## PIC16C76 Rev. A Silicon Errata Sheet

The PIC16C76 (Rev. A) parts you have received conform functionally to the Device Data Sheet (DS30390E), except for the anomalies described below.

## Clarifications/Corrections to the Data Sheet:

**FIGURE 1: WRITES TO TIMER1 (EXTERNAL CLOCK / OSCILLATOR MODE)**

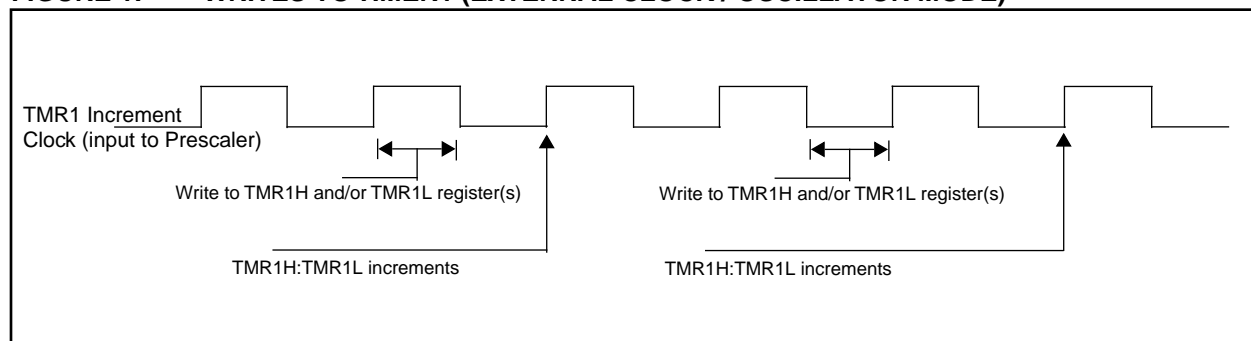
- a) The operation of Timer1 needs some clarification when the timer registers are written when the TMR1ON bit is set.

The internal clock signal that is the input to the TMR1 prescaler affects the incrementing of Timer1 (TMR1H:TMR1L registers and the Timer1 prescaler). When the Timer1 registers are NOT written, the Timer1 will increment on the rising edge of the TMR1 increment clock.

When the TMR1H and/or TMR1L registers are written while this clock is high, TMR1 will increment on the next rising edge of this clock.

When the TMR1H and/or TMR1L registers are written while this clock is low, TMR1 will not increment on the next rising edge of this clock, but must first have a falling clock and the rising clock for TMR1 to increment.

Figure 1 shows the two cases of writes to the TMR1H and/or TMR1L registers. Due to the  $V_{IH}$  and  $V_{IL}$  thresholds on the oscillator/clock pins, external Timer1 oscillator components, and external clock frequency, the Timer1 increment clock may not be of a 50% duty cycle.

The TMR1 increment clock is out of phase of the T1OSO/T1CKI pin by a small propagation delay.
